Briefing Note

ITEM 02 - Land At Singapore Road And Green Man Lane Green Man Lane West Ealing W13 0SN - 223093HYBRID

Planning Committee:18/01/2023

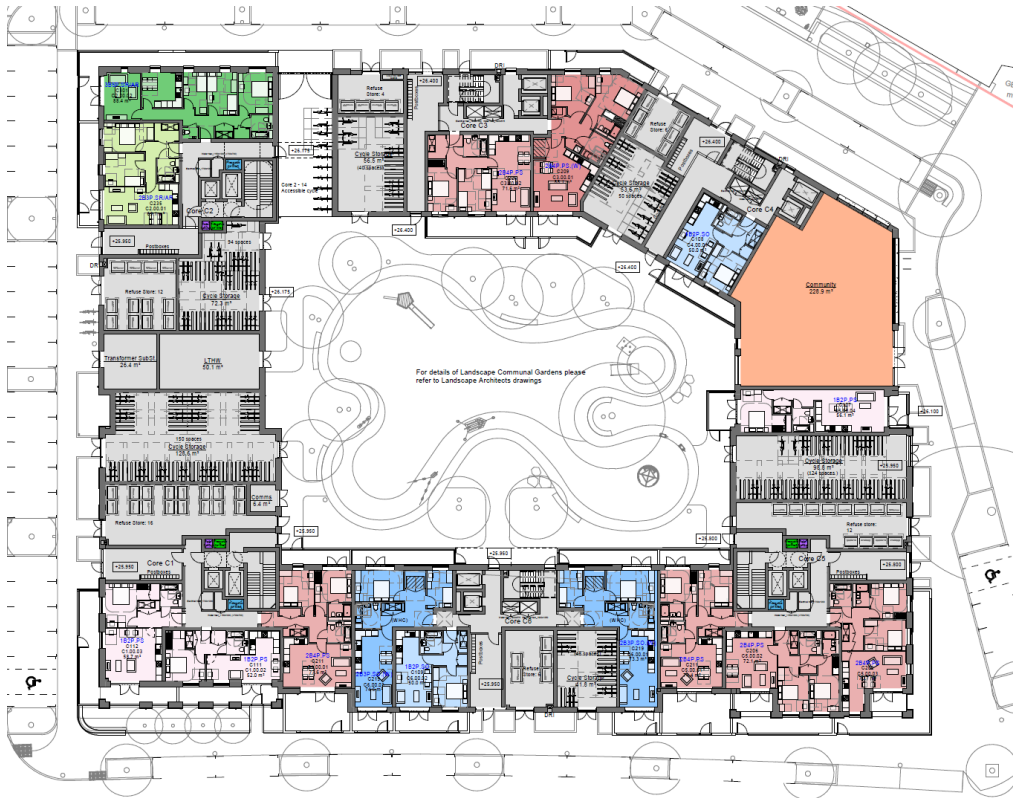
Sketch diagrams of all floors for Blocks C1 and C5 have been carried out, which demonstrate a second staircase could be accommodated by reducing a 2-bedroom flat on each level within each block to a 1-bedroom flat. This would result in a reduction of 28 habitable rooms of private market housing across the scheme, but no loss in the total number of units. Based on these indicative plans where changes are to occur, a summary of the potential impacts is succinctly shown in the table below.

Submitted Application (HR)	Additional Stair Implications (HR)
Private Habitable Rooms	541	513
Affordable Habitable Rooms	513	513
Total	1,054	1,026
Difference		28 HR loss

GROUND FLOOR BLOCK C

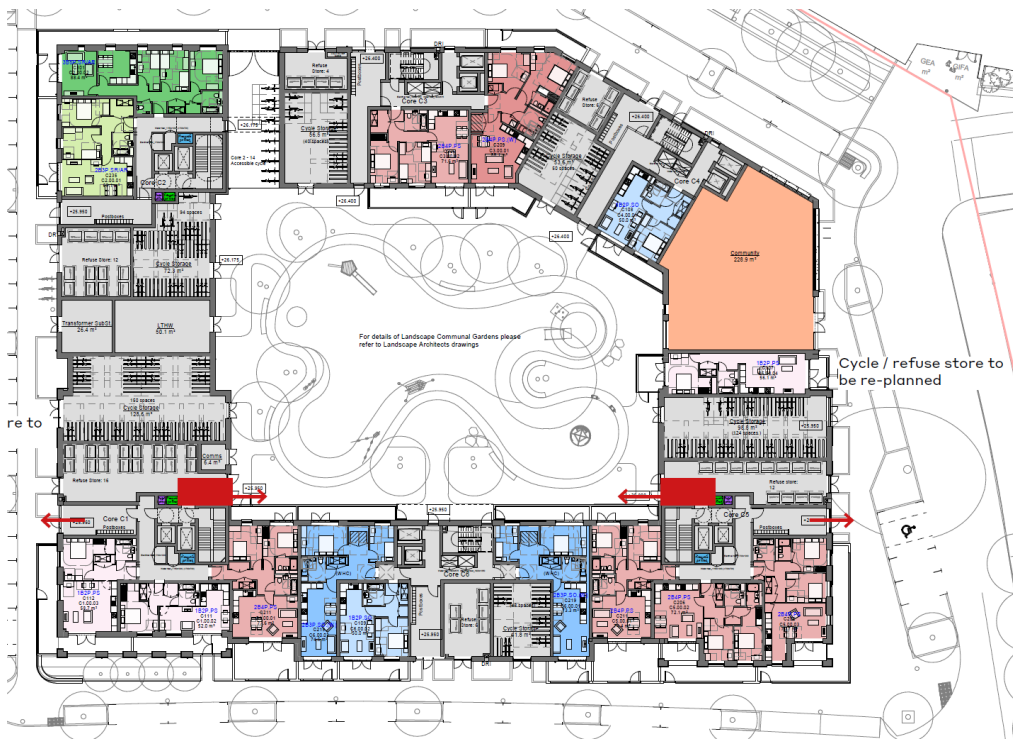
Block C

Changes to the ground floor, requiring the redesign of cycle and refuse storage rooms to accommodate exit points for the secondary staircase. It is anticipated that this can be reasonably redesigned to ensure that the necessary cycle and refuse storage can be accommodated.

GROUND FLOOR BLOCK D

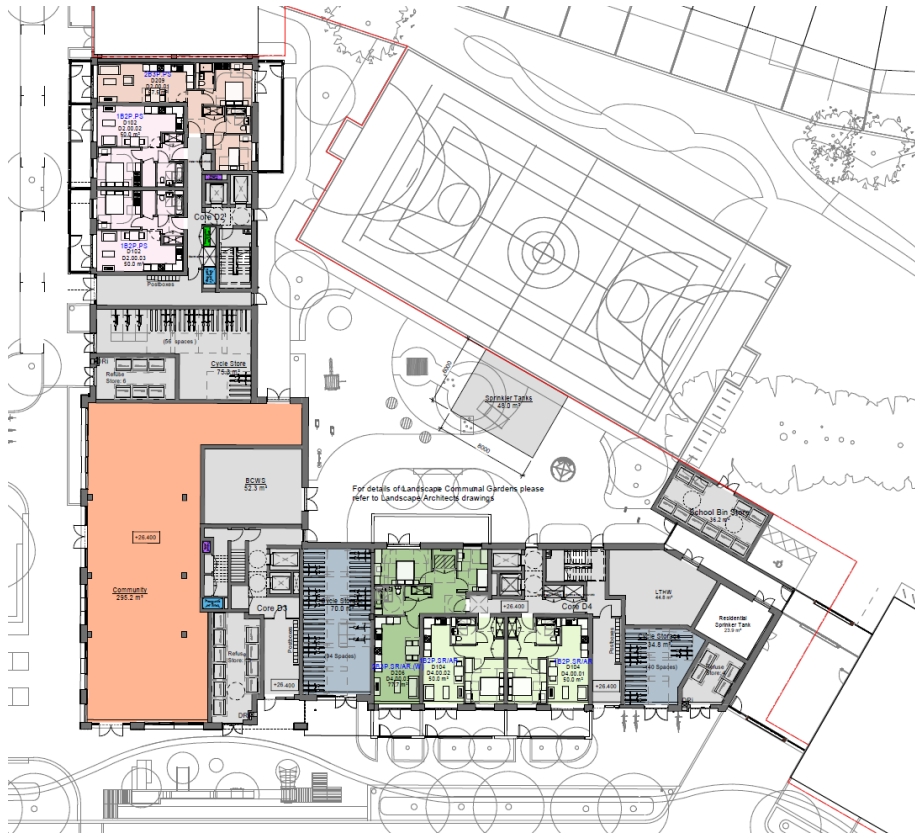
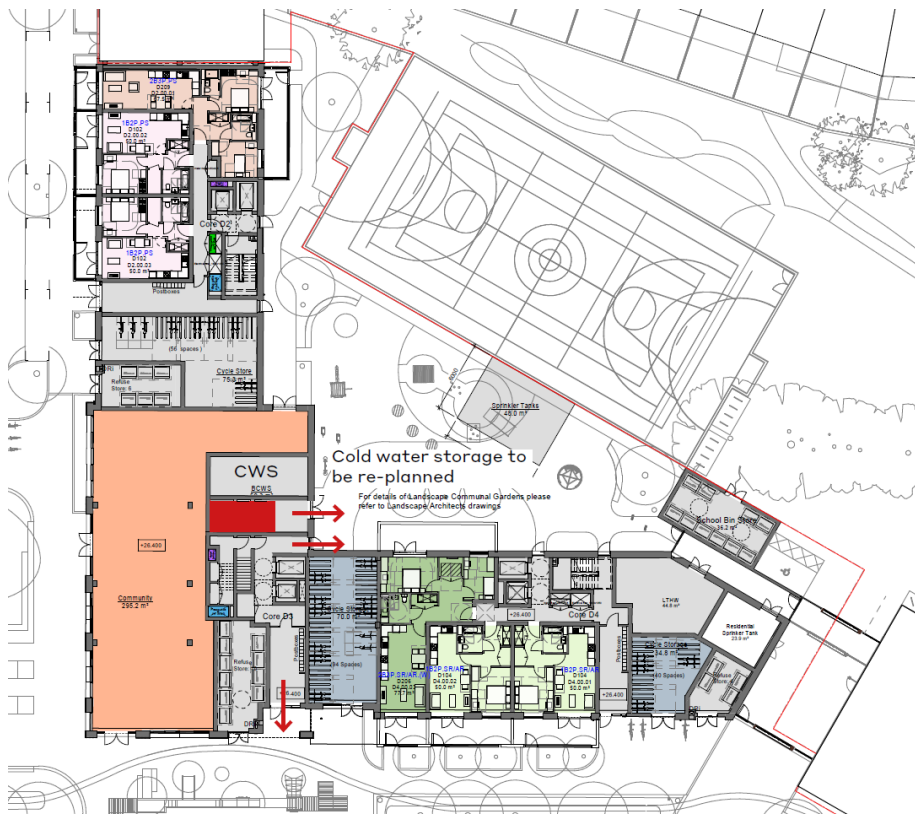
Block D

Changes to the ground floor, requiring the redesign of the cold-water storage to provide an exit point to the communal amenity area for the second staircase.

A second staircase could be provided through each level which would result in changes to the internal layout of a 3b4p flat on each level. There would be no loss of affordable housing units or habitable rooms, but this would likely result in a change to the footprint of the building, increasing one of the eastern walls by an 1 metre circa over all levels.
